US-APWR DCD Revision 3 Tracking Report

April 2012

General Description

This report includes a table that identifies the impact of each response to the Request for Additional Information (“RAI”) relative to the Design Control Document (“DCD”) Revision 3 of US-APWR. This table shows the RAI responses marked in red which have been submitted from December 20, 2011 through March 16, 2012 and also incorporated into the Tracking Report.

Figure 9.4.3-1 Auxiliary Building HVAC System Flow Diagram

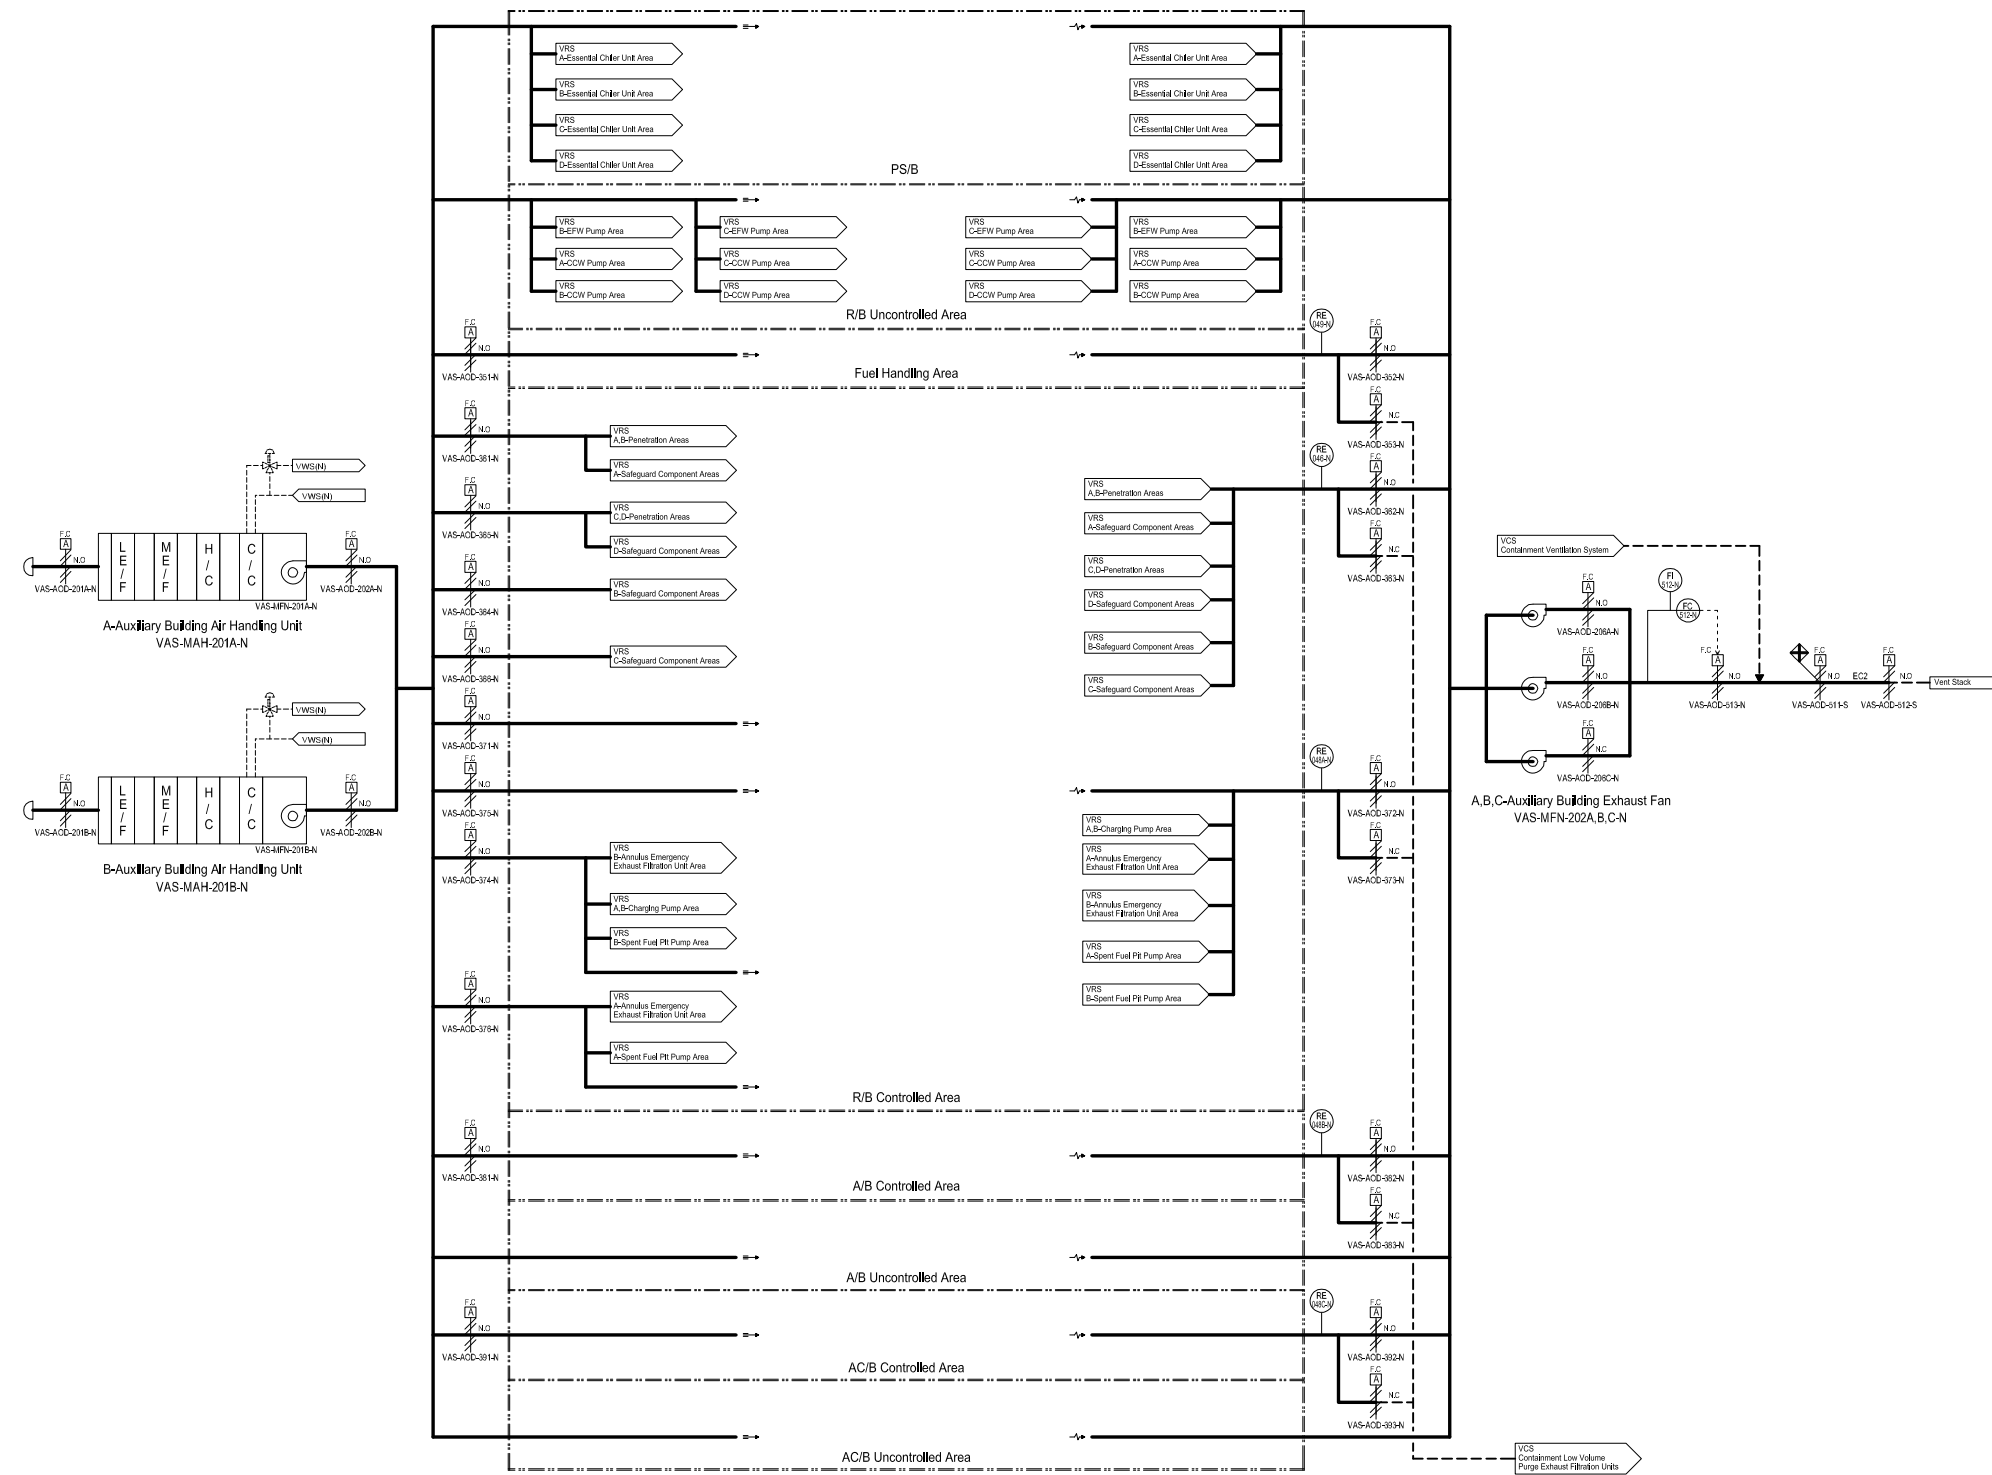
DCD_09.04.03-16	9.4.3.2.1 Figure 9.4.3-1	9.4-13 9.4-79	Response to RAI No. 779 MHI Letter	In fifth paragraph of subsection 9.4.3.2.1, replaced "208,000	-

Change ID No.	Location (e.g., subsection, table, or figure)	DCD Rev.3 Page *	Reason for Change	Change Summary	Rev. of T/R* *
			No. UAP-HF-11259 Date 08/11/2011	ft ³ /min” as the total exhaust airflow of two auxiliary building exhaust fans with “216,000 ft ³ /min” to be consistent with Table 9.4.3-1. Revised Figure 9.4.3-1.	
DCD_09.04.03-15	9.4.3.2.1	9.4-13	Response to RAI No. 779 MHI Letter No. UAP-HF-11259 Date 08/11/2011	Added the following as the last sentence of fifth paragraph of subsection 9.4.3.2.1. “Backdraft dampers are provided in the ventilation duct supplying and exhausting uncontrolled areas to prevent backflow from the auxiliary building HVAC system.”	-
DCD_09.04.03-14	9.4.6.2.4.1	9.4-43	Response to RAI No. 779 MHI Letter No. UAP-HF-11259 Date 08/11/2011	In eighth paragraph of subsection 9.4.3.2.1, replaced “When exhaust from the auxiliary building HVAC system is filtered by the containment low volume purge exhaust filtration unit, ...” with “Before exhaust from the auxiliary building HVAC system is aligned to the containment low volume purge exhaust filtration unit, ...”	-
